**Upper Leon MWD
Intermediate Pump Station Improvements**

Addendum No. 1

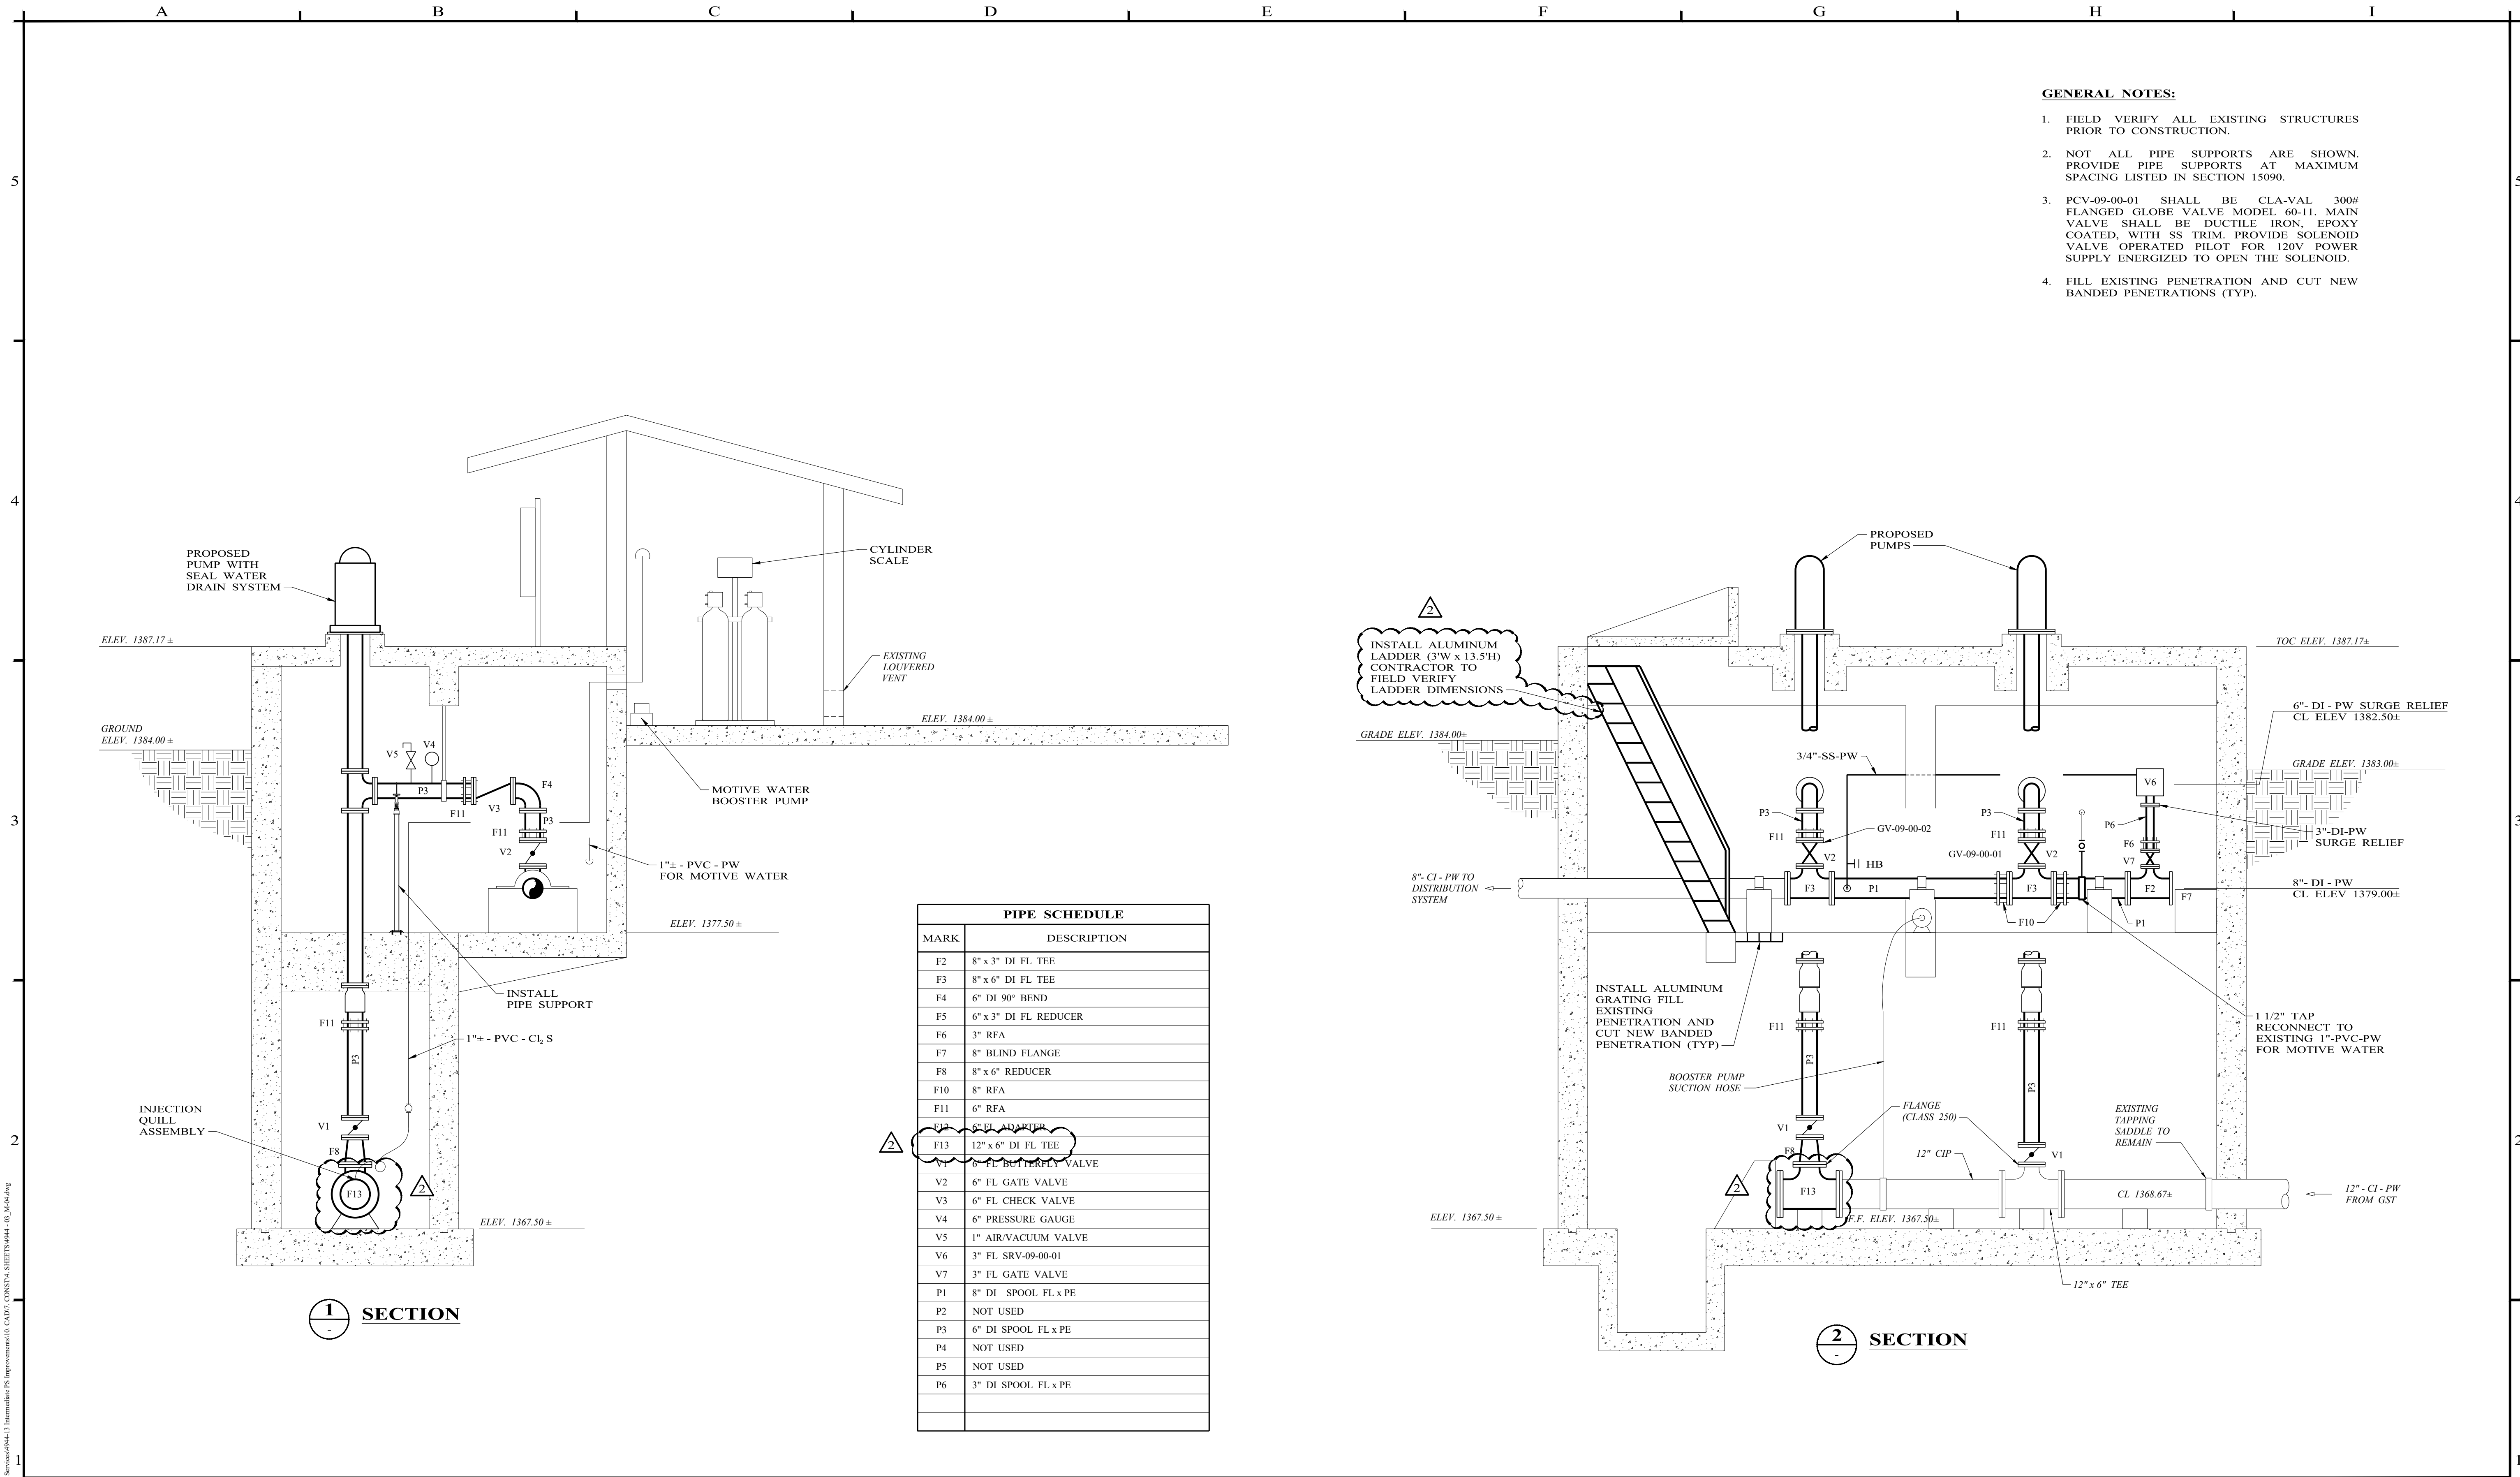
3. The existing bladder tanks and tubing shown on Plan Sheet 6 are for information only. No scope for this system is included in the project.
4. To the greatest extent possible, one pump should remain in operation during improvements while the other pump is being replaced. Shutdown durations for the entire pump station are limited to 6 hours (per Plan Sheet 3) with as much advanced notice with operations as possible.
5. Handrail and toe board are not required for the landing.
6. Utilize the first available spare analog input and analog output in the existing RTU when connecting AO1 and AI2.
